\$Id: PreampsTest.sch 63 2010-03-19 08:56:40Z stephan \$

FILE: PreampsTest.sch

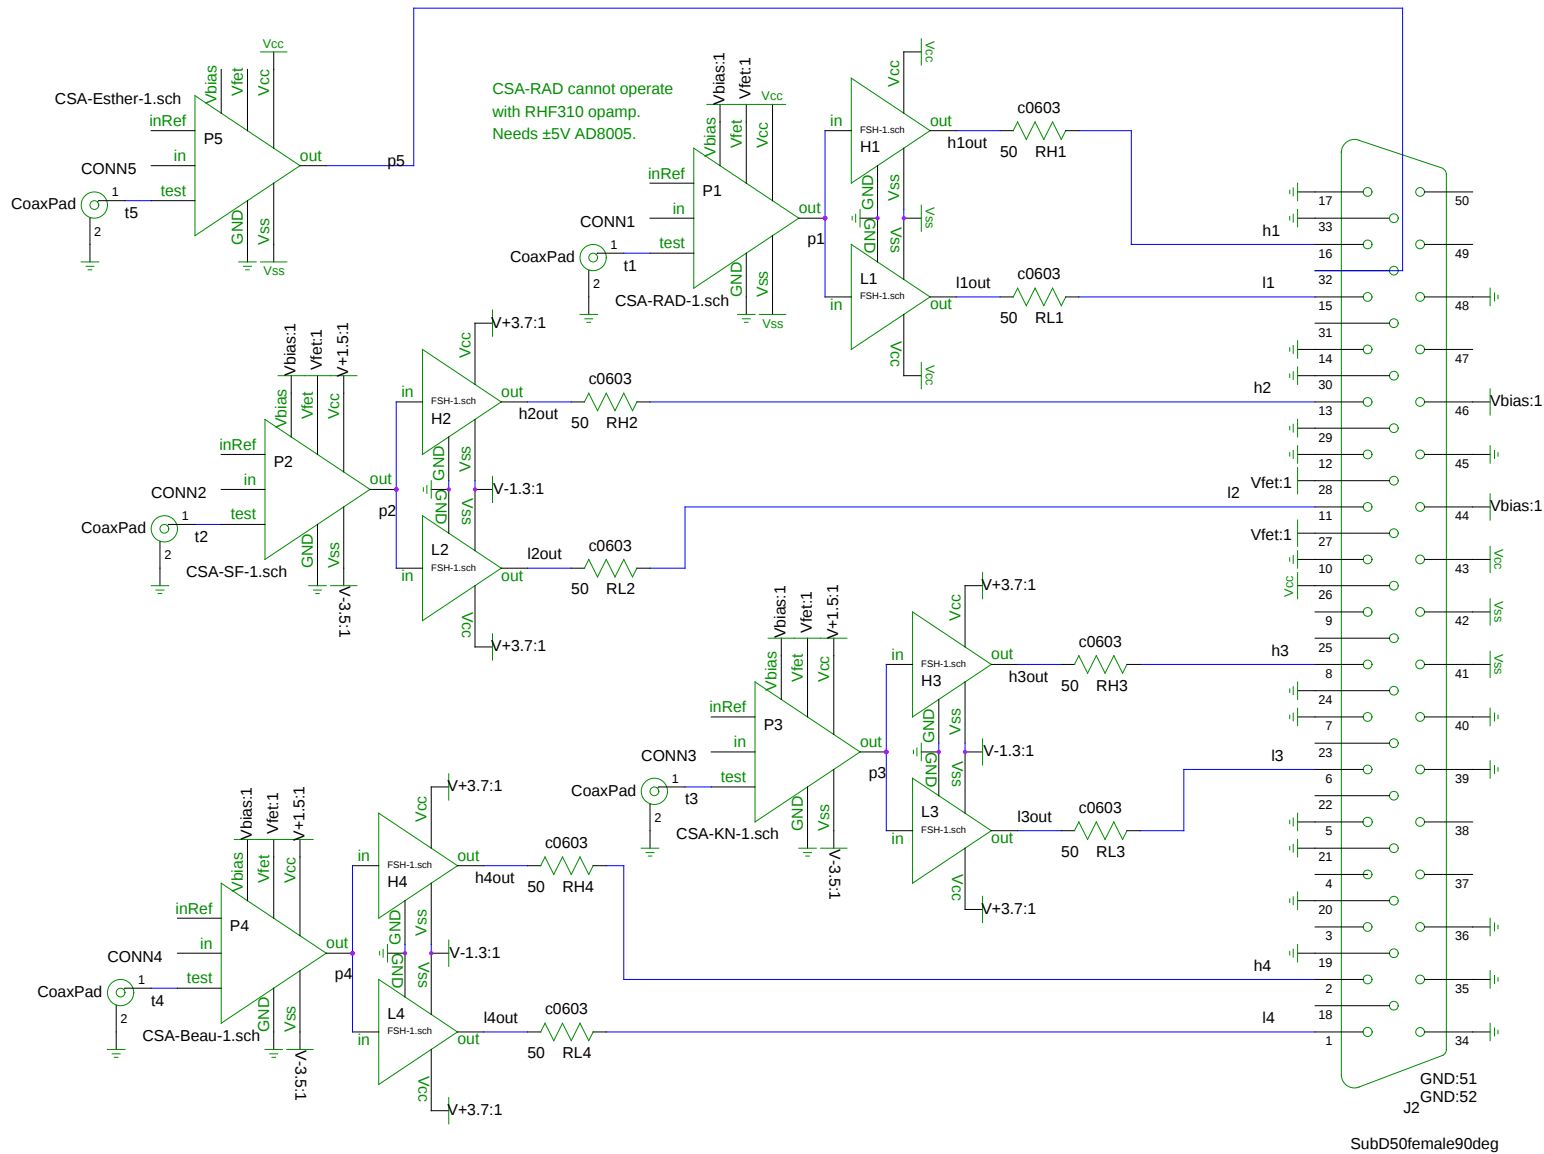
CSA-RAD cannot operate
with RHF310 opamp.
Needs $\pm 5V$ AD8005.

For AD8005 $\pm 5V$ operation
replace LDOs with wire bridge
